VILLAGE OF WAPPINGERS FALLS

AGENDA OF THE PLANNING BOARD

Re: Dutchess Ave and Garden St, 2nd Review Tax ID#: 135601-6158-17-198119

VILLAGE OF WAPPINGERS FALLS FOUR CORNERS PLANNING COMMENTS, DATED MARCH 1, 2023:

SITE PLAN

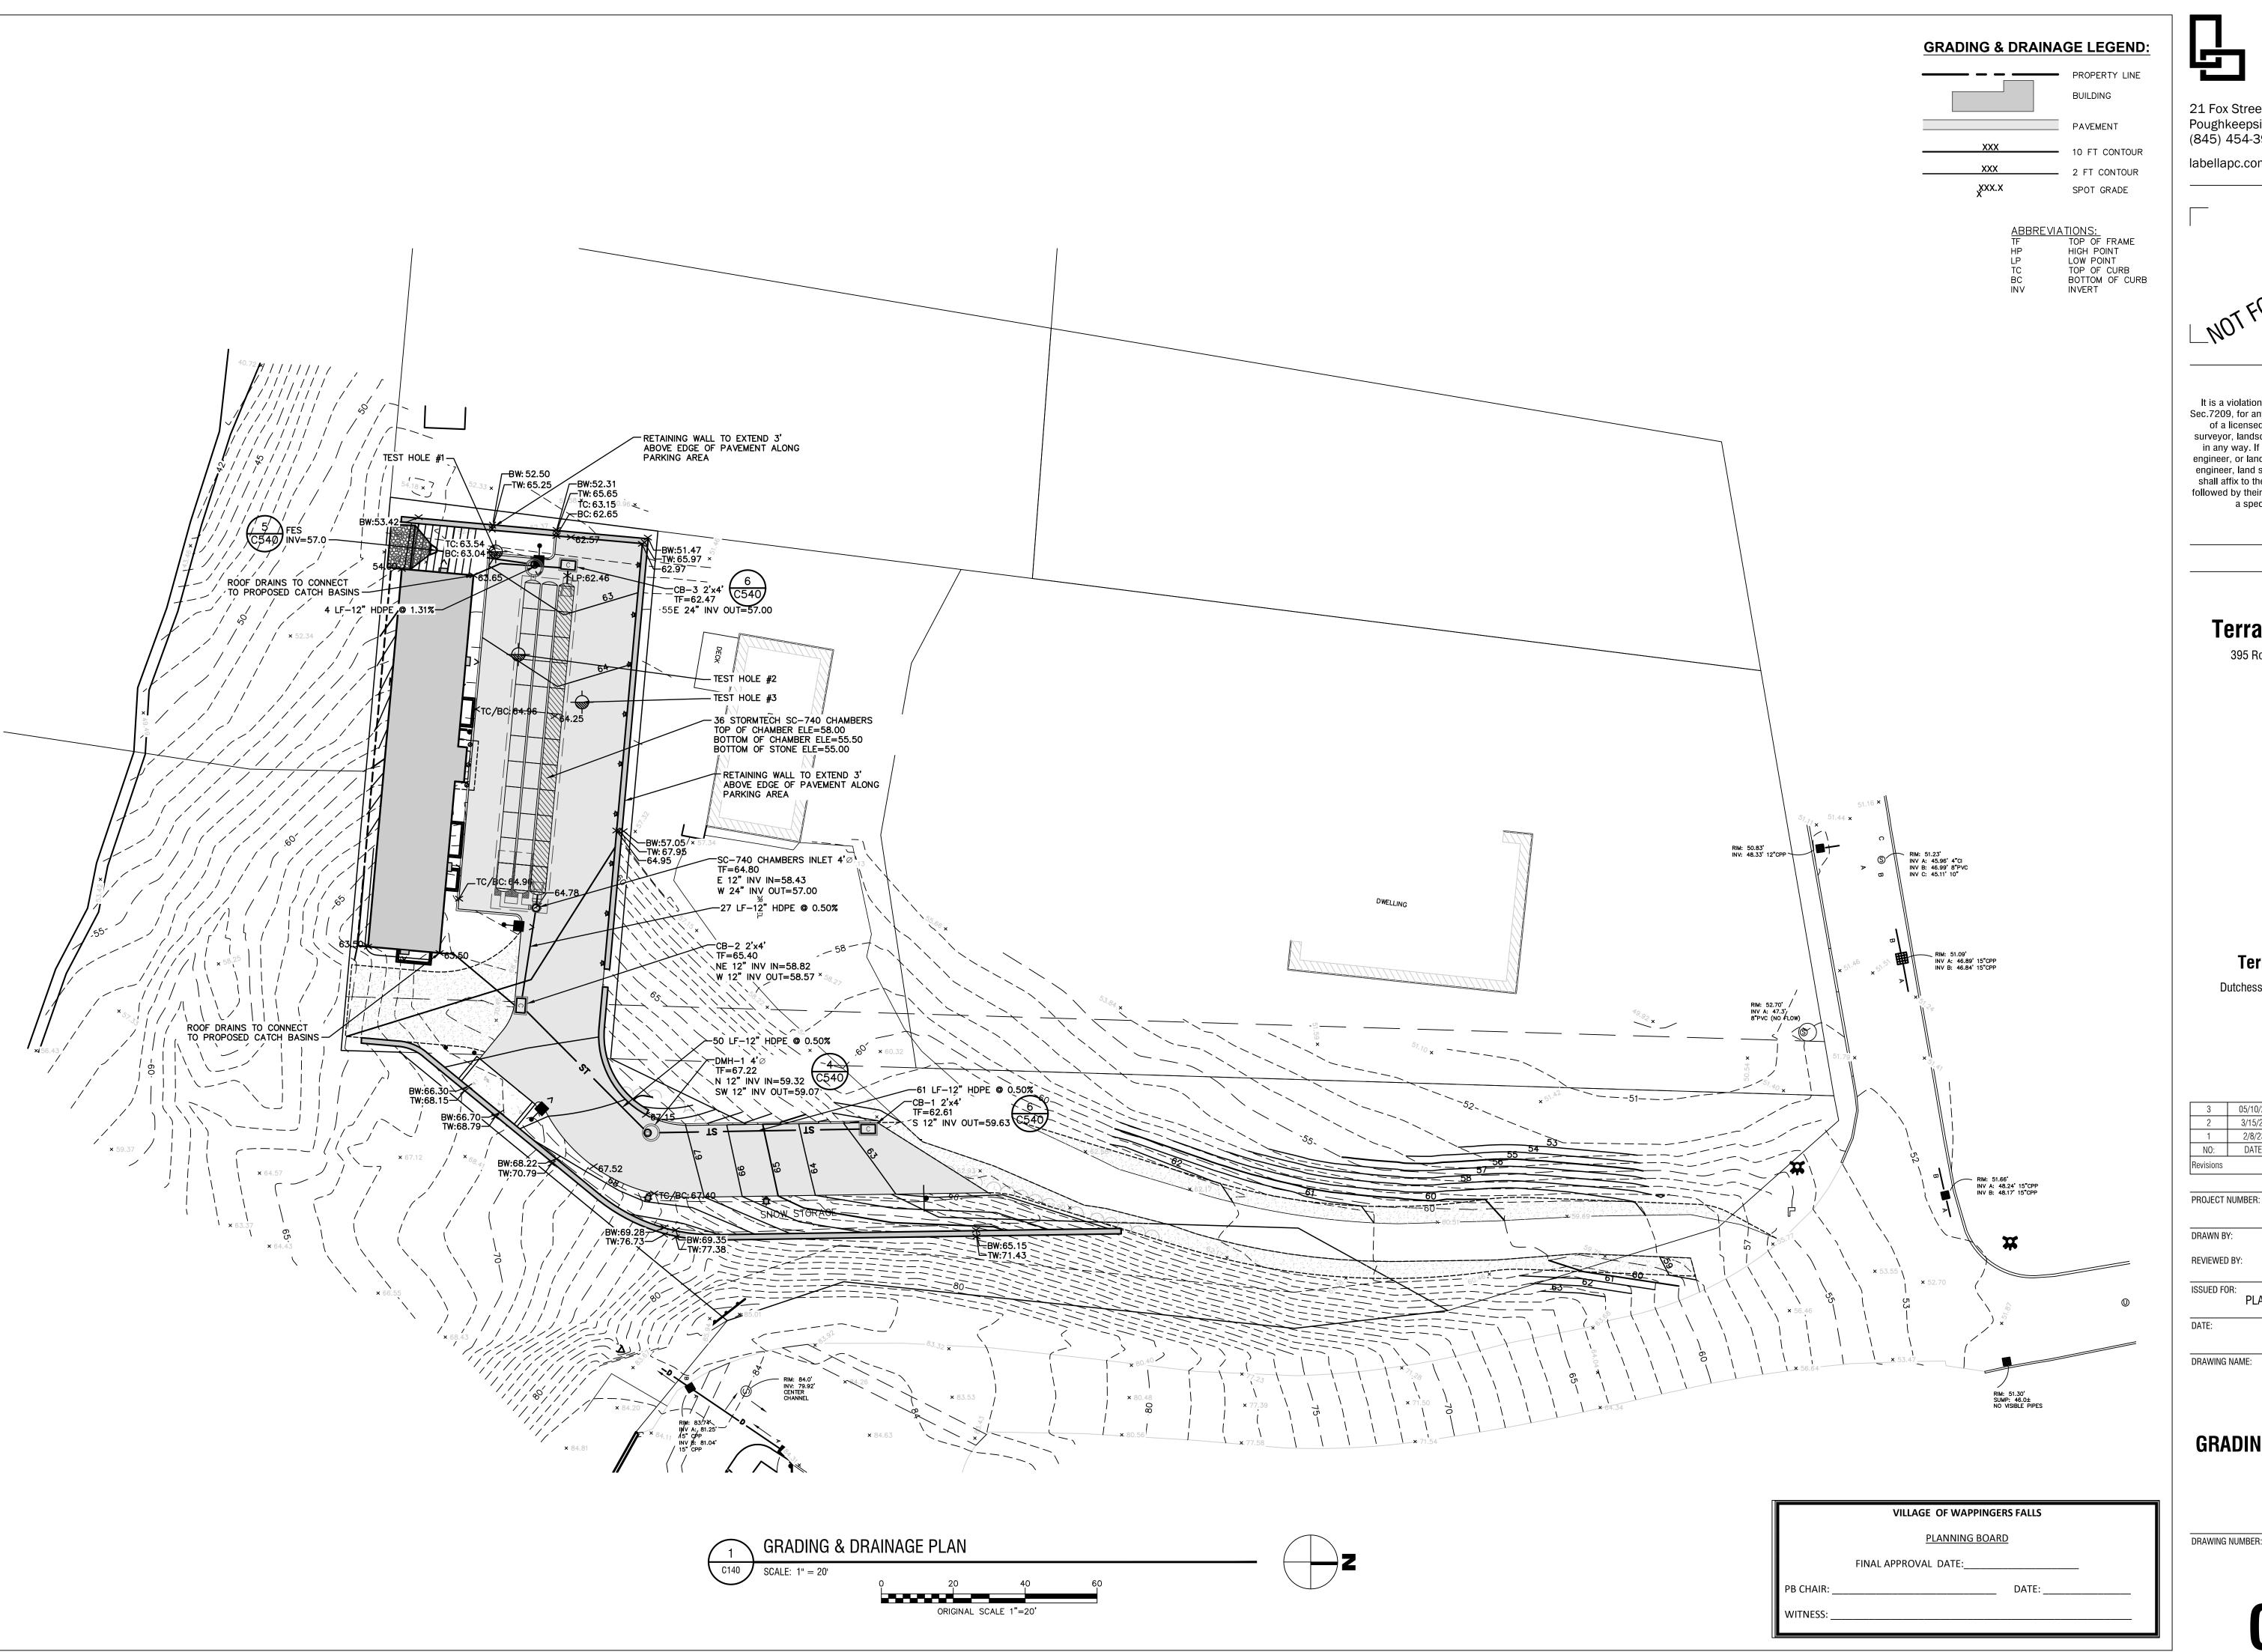
10. Applicant should provide guide rail along driveway at proposed 1 in 2 fill slope.

Response: This was included in the last submission and is shown on sheet C130.
